Final

environmental statement

**related to construction of
BELLEFONTE NUCLEAR PLANT
UNITS 1 AND 2**

DOCKET NOS. 50-438 and 50-439

Fig. 1.1. Preliminary Layout of Bellefonte Plant. From TVA DES.

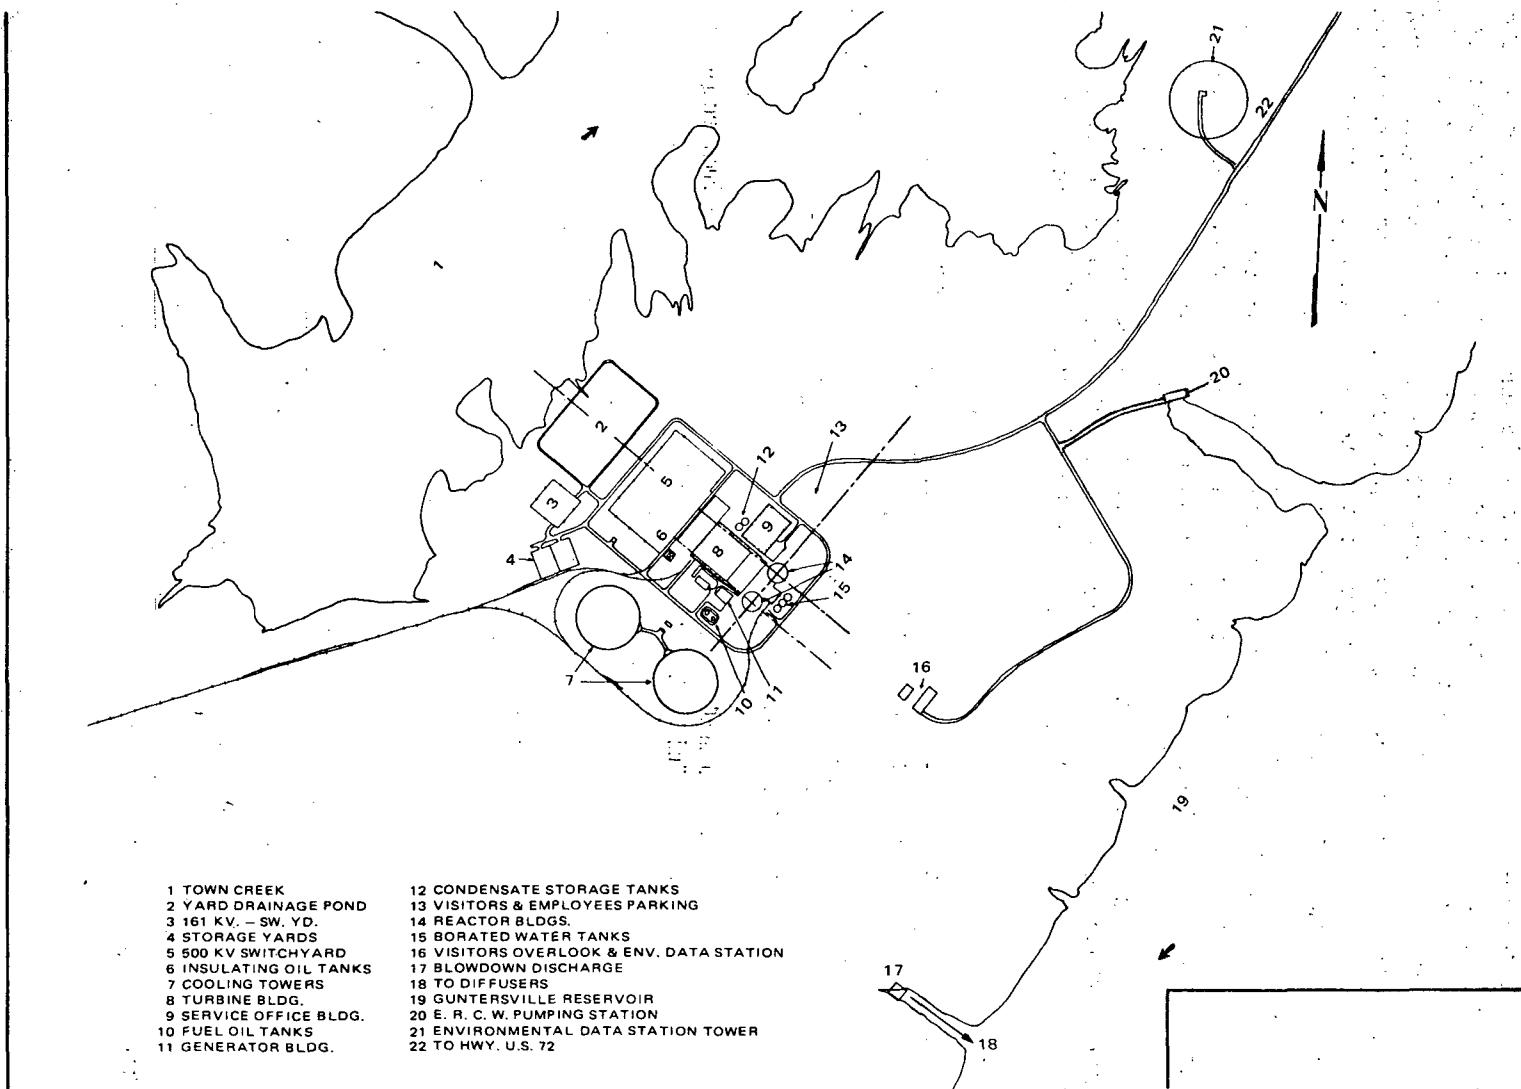
The preliminary layout of the Bellefonte Plant shown on figure 1.1 indicates that a "yard drainage pond" would be constructed along the edge of Town Creek embayment and immediately northwest of the plant. The proposed pond is also illustrated in an artist's drawing of the proposed plant in figure 3.1 and appears to be a diked enclosure covering about 13 acres. However, the design of construction of the pond, and its perimeter dike and outlet; and the depth or amount of any excavation required to construct this facility, or of any related environmental impacts should be discussed in the final statement. The discussion of this pond on pages 3-16 is inadequate.

Fig. 3.3. Radioactive Gaseous Waste System.

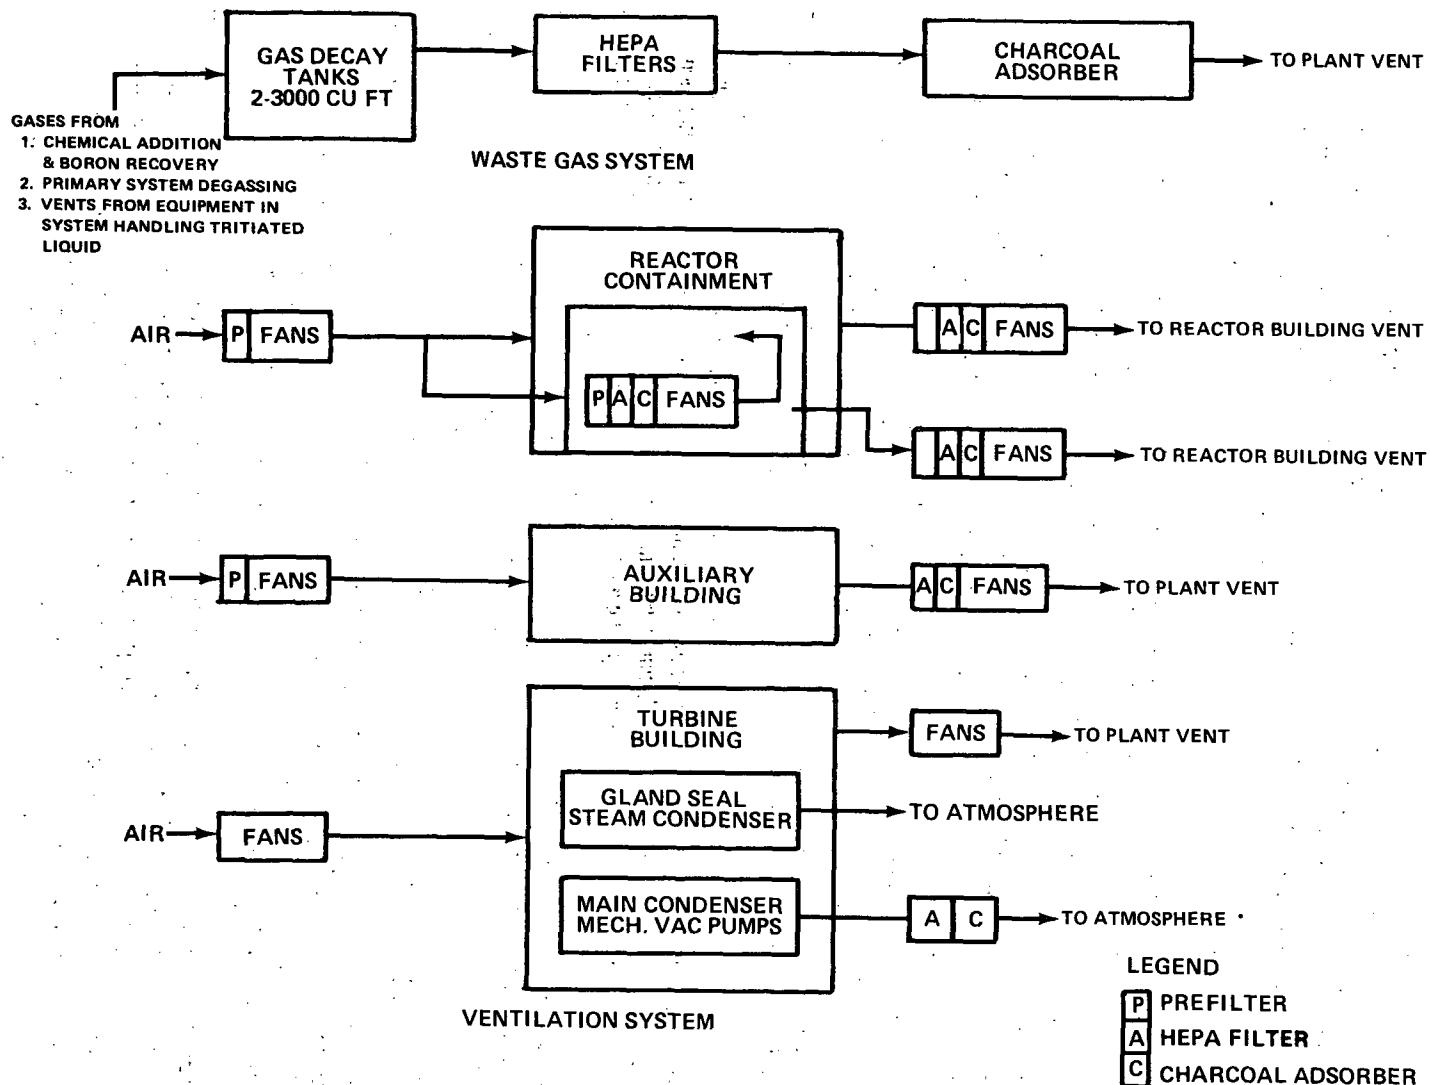
1. Figure 3.3 should show treatment of gaseous release from the air ejector as a component of the gaseous waste treatment system, as mentioned on page 3-11.
